**REMARKS**

TITLE: METHOD AND APPARATUS OF INTERPOSING  
VOLTAGE REFERENCE TRACES BETWEEN SIGNAL  
TRACES IN SEMICONDUCTOR DEVICES  
Serial No.: 09/548,942  
Docket No.: 2269-4161US  
ANNOTATED SHEET SHOWING CHANGES

**Fig. 11**

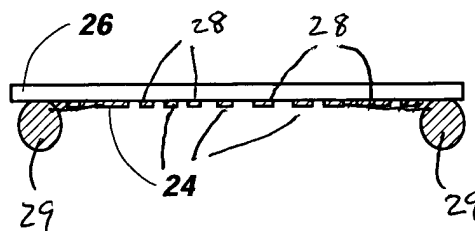
“[t]he specification needs to provide an explicit description with respect to the FIG. 11 embodiment of the connection of the solder balls to at least one signal trace and the voltage reference signal as recited in amended claims 24 and 31. Since this amended limitation is considered not to be “new matter,” then an amendment to the fig. 11 adding the amended claim limitation would be appropriate.”

The attached sheet of drawings includes changes to FIG. 11. This sheet, which includes FIGS. 6-11, replaces the previous drawing sheet including FIGS. 6-11. In FIG. 11, the solder balls are shown as being connected to at least one signal and at least connected to the voltage reference signal, as suggested by the Examiner. (See attached Replacement Sheet and Annotated Sheet Showing Changes.)

Fig. 11 has been modified to show the solder balls being connected to at least one signal and at least connected to the voltage reference signal, as suggested by the Examiner.
